UNITED STATES PATENT AND TRADEMARK OFFICE

10/590,638

Office Action Summary	Application No.	Applicant(s)	
	10/590,638	RAMSAUER, DIETER	
	Examiner	Art Unit	
	KRISTINA R. FULTON	3673

DETAILED ACTION

Fig. 3.

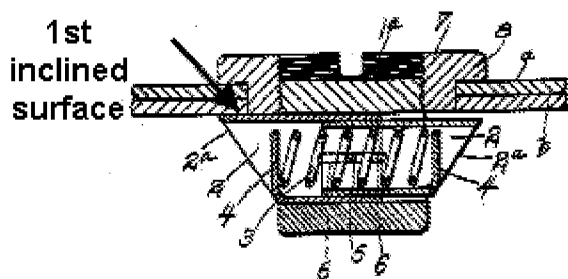
1. Claims 28-29, 31, 34 are rejected under 35 U.S.C. 102(b) as being anticipated by (Witzberger US 1426239).
2. Regarding claim 28, Witzberger teaches a latch for mounting in a thin wall (plates a,b) having a head part (8) arranged outside a thin wall which overlaps an outer rim of the opening, a body part (1) which proceeds from the head part and projects through the opening in the mounted position, holding elements (2) which project from the body

part and are displaceable in a direction of the elements' outer surfaces, a free end of the holding elements being provided with a first inclined surface (see figure below – Please note that “inclined” is defined as “tending in a direction that makes an angle with anything else” –source: Dictionary.com. Therefor without a reference the surface as labeled below can be considered inclined. Further, please note that if applicant intended to claim that the surface is inclined with respect to the wall; please see applicant's provided art 883121 where surface 22 is at an incline. Please note that 883121 is used for support and is not part of the rejection) for supporting the body part without play on the rim wherein the first inclined surface rests on the rim of the opening in the mounted position wherein said free end of said holding elements being further provided with a second inclined surface (2a) for slam action, the second inclined surface being approximately at a right angle to the first; wherein the holding elements are slides that diametrically oppose each other; the body part and the holding elements being separate parts and are arranged to be displaceable in the cylinder of the body part parallel to the plane of the thin wall.

3. Regarding claim 29, the slides are held against a pressure spring force (3) by a hook arrangement (slots 6 hook onto pin 5).
